Addendum No. 1 to IFB #25-55

To: All Parties on Record with the City of Somerville as Holding IFB #25-55
2025 Sewer Rehabilitation

Re: Questions and Answers

**City of Somerville, MA
2025 Sewer Rehabilitations
Addendum No. 1**

Sheet Number:
C109

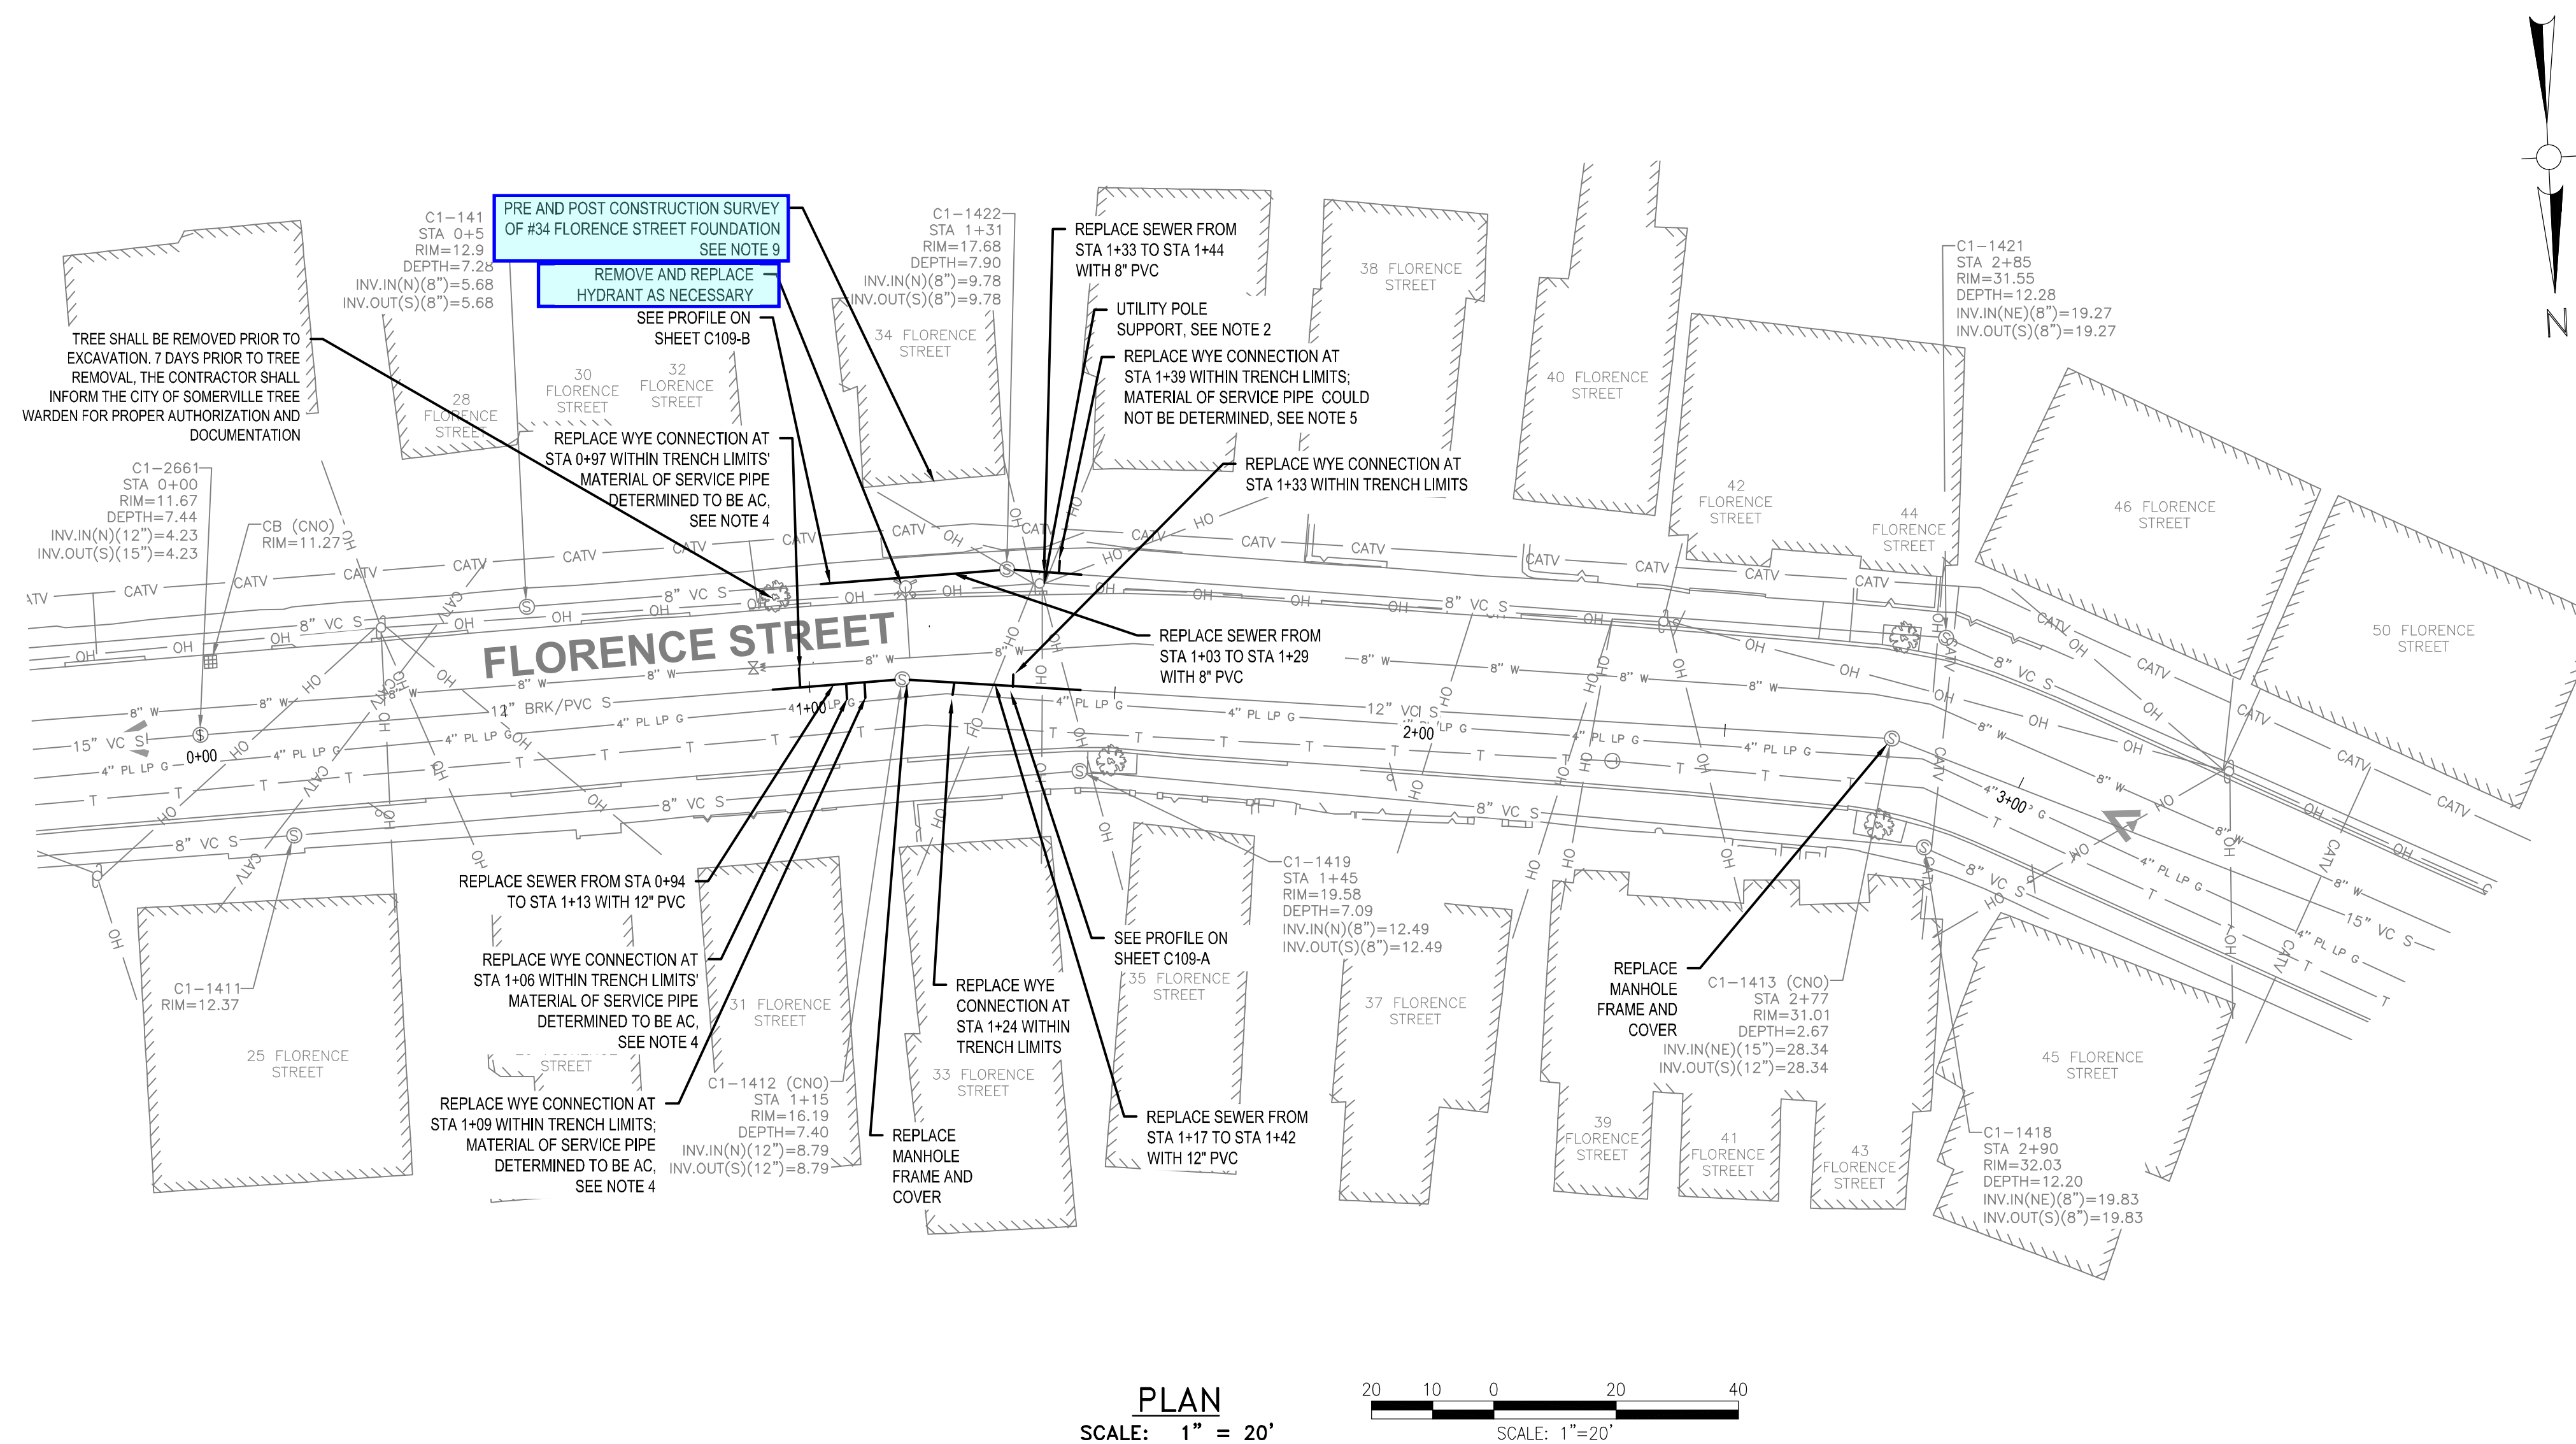
Question 10: On sheet C111, there is a call out to remove & replace the hydrant as necessary. Will this be paid under item 8a: Water and Drain Reconstruction? Also, on sheet C109, there is a hydrant not shown at #34 Florence Street in close proximity to the sewer relay from STA

1+03 to STA 1+29. Should the bidder figure to remove & replace hydrant similar to the call out on sheet C111, Perkins Street?

Yes, for the hydrant near #34 Florence Street, this hydrant shall be handled in the same manner as the hydrant on C111 on Perkins Street as described above. Removal, protection, and replacement of the hydrant near #34 Florence Street on C109 shall be included as incidental to the adjacent excavation work between and shall not be measured separately for payment, as described in Section 01 22 00 – Measurement and Payment, 1.02.A.8. Section 01 22 00 – Measurement and Payment, 1.02.A.8 has been updated to include this hydrant. Sheet C109 has been updated to show the missing hydrant with a call-out.

C111

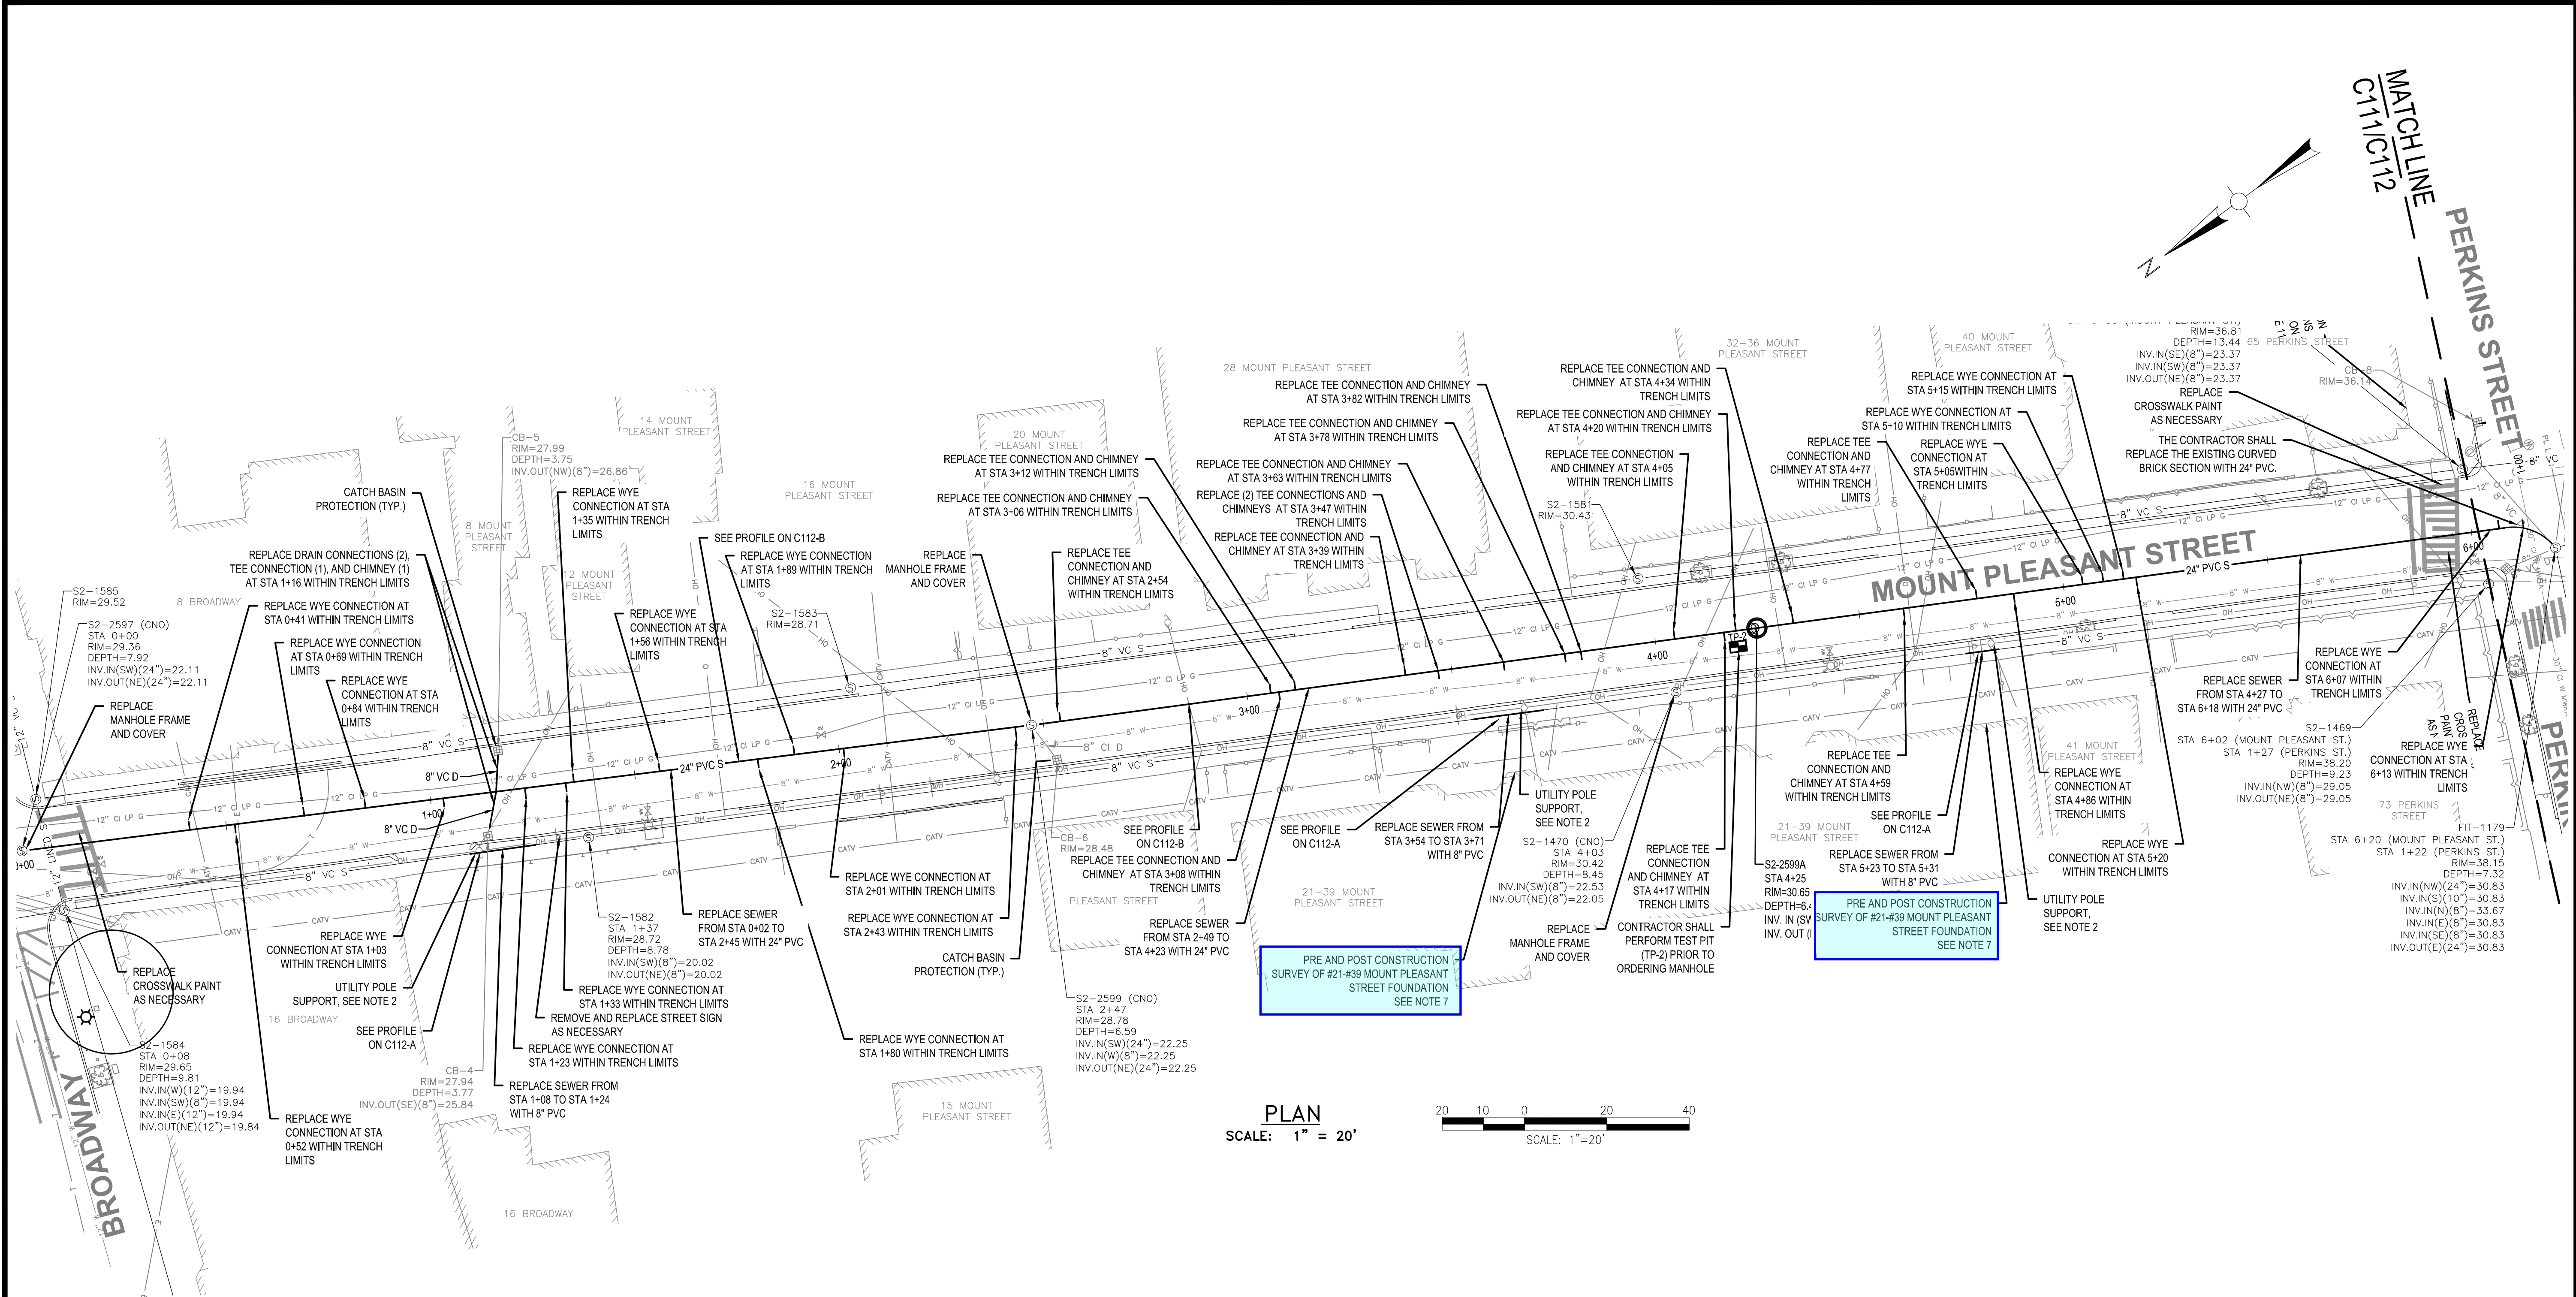
Question 11: On sheet C111, at the intersection of Perkins Street at Mount Vernon Street the drawings call to replace sewer from STA 3+49 to STA 3+58 with 12” PVC. Can the bidder assume the plan view was not bolded / highlighted but is the intent of designed work?

Answer 11: The section of sewer to be replaced between STA 3+49 to STA 3+58 with 12” PVC between manhole S2-1476 to S2-1475 is highlighted on the plan view of sheet C111. The pipe label and proposed work leader have been moved to different positions to clearly view the proposed replacement highlight.
